PHAP15-00048

Date:	December 21, 2015
Application Type:	Certificate of Appropriateness
Property Owner:	Peter Svarzbein
Representative:	Peter Svarzbein
Legal Description:	Being 21 Sunset Heights E. 60 Ft. of 9 To 12 & E. 60 Ft. of N. 20 Ft. of 8, City of El Paso, El Paso County, Texas
Historic District:	Sunset Heights
Location:	900 W. Yandell Drive
Representative District:	#8
Existing Zoning:	A-2/H (Apartments/Historic)
Year Built:	1955
Historic Status:	Non-Contributing
Request:	Certificate of Appropriateness for the connection of two separate balconies, forming one, larger balcony using metal pickets to match existing
Application Filed:	12/16/2015
45 Day Expiration:	1/30/2016

Certificate of Appropriateness for the connection of two separate balconies, forming one, larger balcony using metal pickets to match existing

PROPOSED PLAN AND ELEVATION

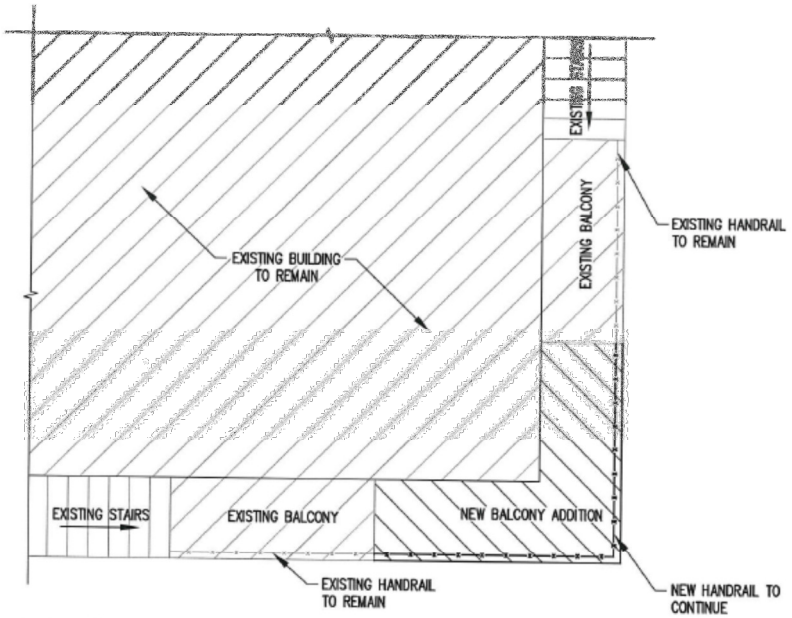
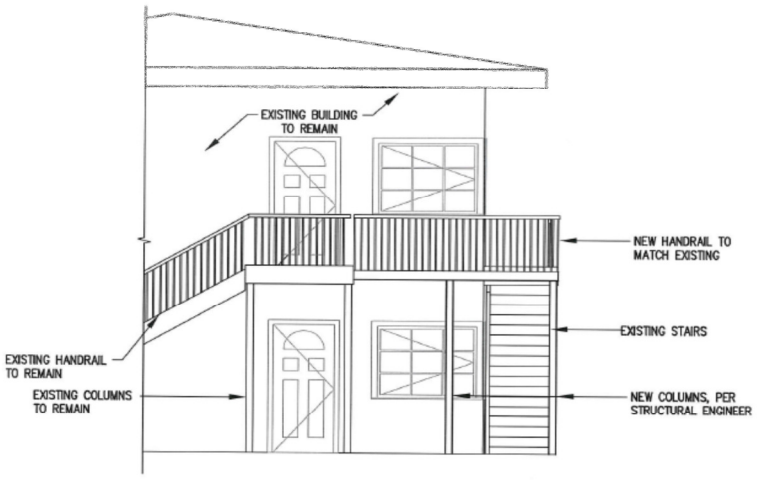
The Historic Preservation Office recommends that the application be postponed until a complete elevation of the new feature is submitted based on the following recommendations:
